Houston Lighting & Power

August 30, 1988  
ST-HL-AE-2764  
File No.: G20.02.01, M20.1  
10CFR50

South Texas Project Electric Generating Station  
Units 1 and 2  
Docket Nos. STN 50-498, STN 50-499  
Revised Responses to NRC Questions Regarding the  
Use of High Density Spent Fuel Racks

SOUTH TEXAS PROJECT  
Units 1 & 2  
Docket Nos. STN 50-498, STN 50-499  
Revised Responses to NRC Questions  
on Spent Fuel Racks

FUEL GAP STUDY

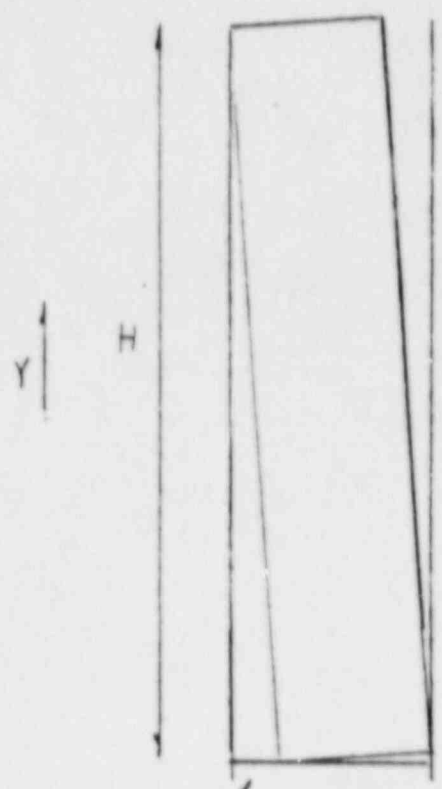
The NRC requested that UST&D review their analysis to ensure that all possible situations of gap between the fuel assembly and rack side have been addressed and that the "worst-case" is considered. The results of this review will be submitted to the NRC during the week of July 23, 1988.

In response to the NRC request additional fuel to rack initial gap configurations runs were made to assure that the "worst-case" was considered. The results, shown below, indicate that the difference in resulting loads are negligible.

ACTION 1A:

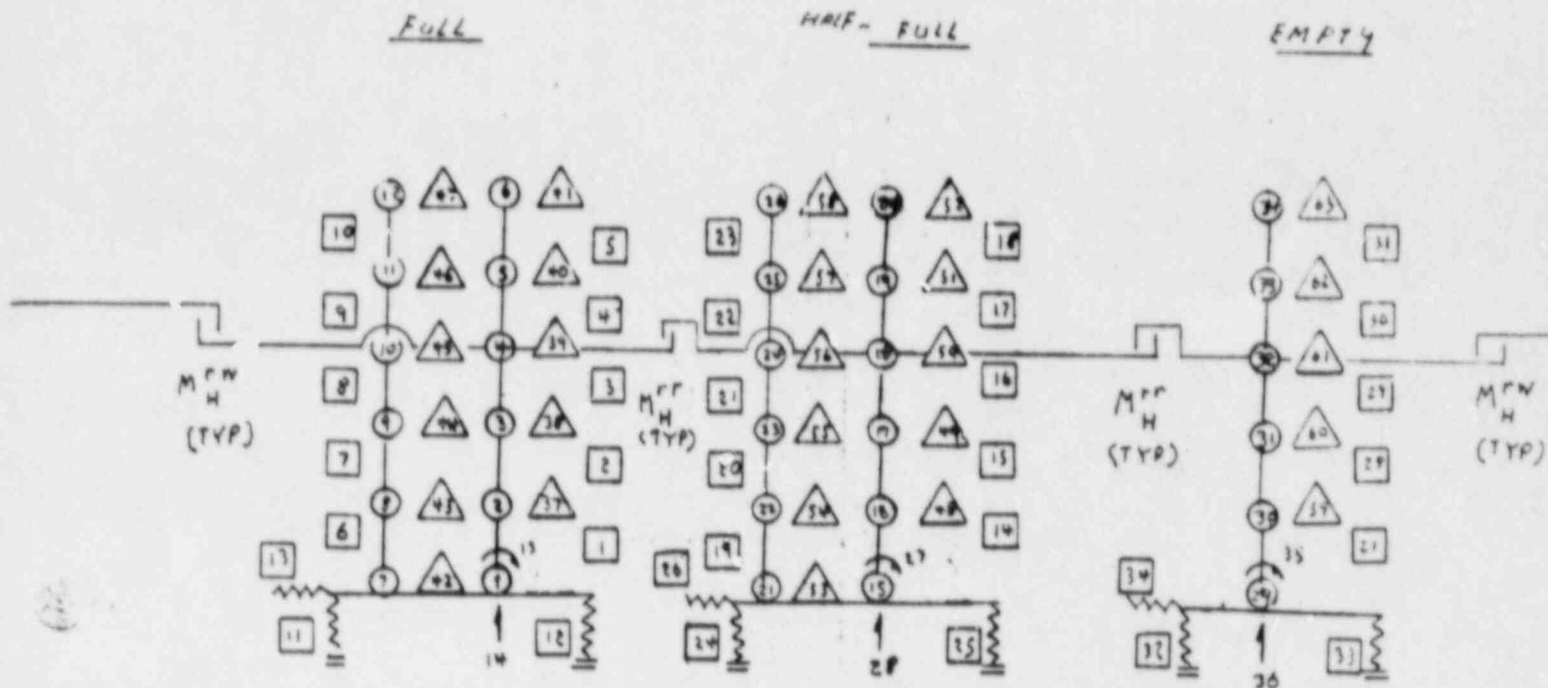
During the July 21, 1988 meeting with the Staff, USf&D presented a detailed discussion of the hydrodynamic mass matrix model. The hydrodynamic mass matrix model for STP is based on a 1-inch rack-to-rack gap. The base model is a 3-rack model (132-cell racks) with the first rack filled with <sup>3 rack</sup> consolidated fuel, the second rack half filled with <sup>3 rack</sup> consolidated fuel, and the third rack empty. Using a 0.2 coefficient of friction (i.e., sliding occurs), the maximum relative motion between racks is 0.128 inches. Using a 0.8 coefficient of friction (i.e., no sliding occurs), the maximum relative motion between racks is 0.29 inches.

Since the hydrodynamic mass matrix model is based on a 1-inch rack-to-rack gap, there is no physical interaction of the racks. As the racks are moved closer together the hydrodynamic coupling forces increase resulting in smaller relative motion between racks. UST&D has performed a similar analysis for another rack order using a 0.25 inch gap. The relative motion between the racks was 0.3 inches. As in the STP analysis, there was no physical interaction between the racks. The relative motion between racks as discussed above for a 1-inch gap and a 0.25-inch gap demonstrates the increasing strength of the hydrodynamic coupling as the rack-to-rack gap is decreased, preventing physical interaction of the racks.

Question 5  
Figure 3

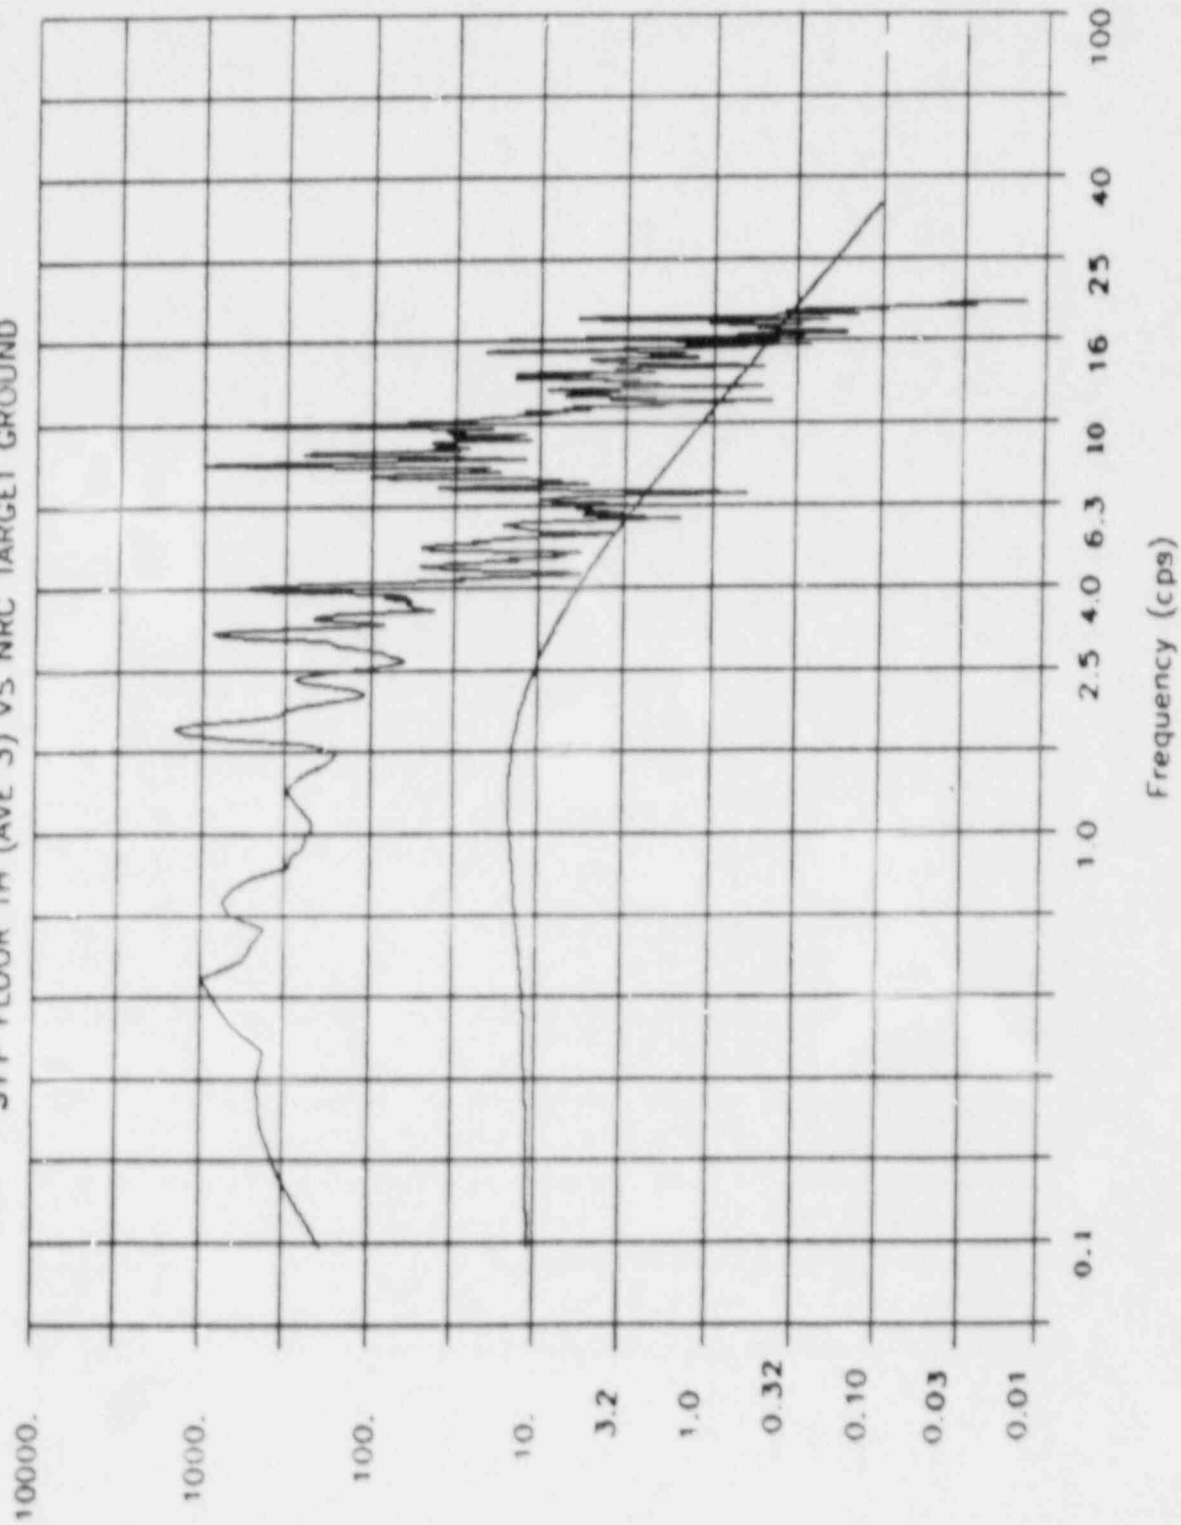
If one (1) synthetic time history is used in analysis of racks, indicate whether the time history had a sufficient energy content at the natural frequency range of the rack.

The PSDs computed for the floor input motions used in the time history analyses of the spent fuel racks are shown in Figures 3 and 4 based on 3-point averaging and Figures 5 and 6 based on 11-point averaging. In general, and particularly in the low frequency range of importance (2 to 4 cps), the computed PSDs exceed the target PSD as evidenced from both sets of curves. At frequencies higher than about 12 cps, the PSD curves based on 3-point averaging are characteristically below the target PSD. However, that is not a significant indication of low energy content since (1) as stated earlier, this condition is not unexpected when PSDs for in-structure motion are compared to the target PSD for ground motion, and

(2) the condition does not affect the 2.5 to 3.0 cps frequency range that corresponds to the dominant and governing lateral response of the racks. Moreover, that apparent underrepresentation of energy content becomes less prominent and its initial frequency of occurrence is shifted upwards (from 12 to 16 cps) when the smoothed 11-point average curves are considered. Another observed characteristic of the PSDs is an apparent low energy content in a narrow frequency band centered at 6.3 cps. This behavior is attributed to the "valley" and "abrupt drop" exhibited by the design-basis spectra at the characteristic frequency of 6 cps (Figures 7, 8 and 9), and it is not related to the synthesization of the artificial time histories. The condition is restricted to the narrow frequency band of 5 to 6.5 cps, thus it is not a significant concern because the rack modes in that frequency range have very low participation factors of 0.002 and 0.003 compared to the higher participation factors of 0.77 and 0.75 for the 2.5 to 3.0 cps modes that dominate the rack lateral seismic response. In summary: (1) the "dips" in the PSD curves at 6.3 cps are traceable to the design-basis spectra and are not originated by a deficiency in the synthetic time histories, (2) the amplitudes of the design-basis spectra have been demonstrated to be conservative by comparison to more rigorous solutions, and (3) the time histories with low PSD values in a narrow range at 6.3 cps are used exclusively in the analyses of the racks which do not have dominant modes in that frequency range. Therefore, it is concluded that the time histories used for the rack analyses are adequate notwithstanding the PSD indications at 6.3 cps.

Question 5  
Figure 8

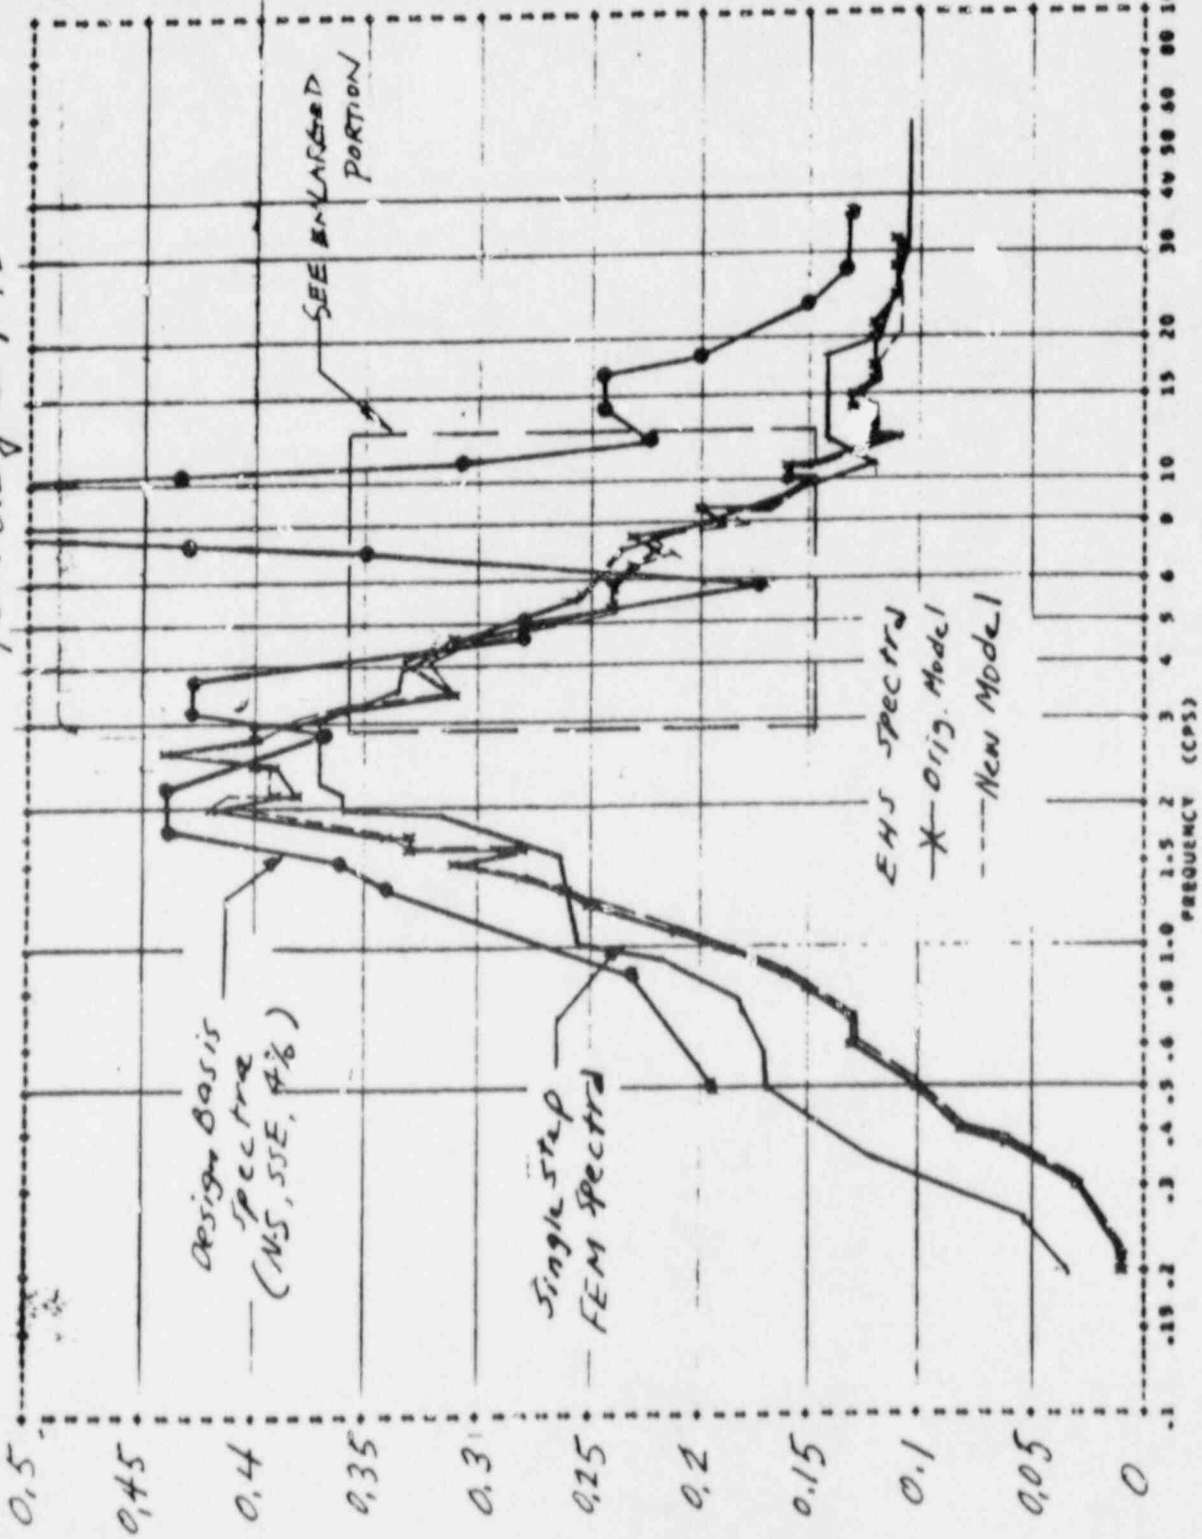
The underrepresentation of the N-S OBE and SSE spectral response within the narrow frequency range of 5.0 to 6.5 cps is a recognized condition as shown in Figures 8 and 9. The E-W and the vertical directions are not affected by this condition.

The total seismic response of the racks due to three-component earthquake is dominated by the E-W direction, which produces substantially higher responses than the N-S contribution. Therefore, an increase in the N-S contribution will be proportionately lower when compared to the total 3-component response, particularly since the square-root of the sum of the squares (SRSS) combination used for the total response tends to diminish the relative importance of the non-dominant components. Moreover, increases in the N-S response are not anticipated because the

slightly higher N-S input corresponding to the rigorous (confirmatory) spectra is restricted to the 5.0 to 6.5 cps frequency range which excludes the 2.5-3.0 cps frequencies of the dominant lateral modes of the racks.
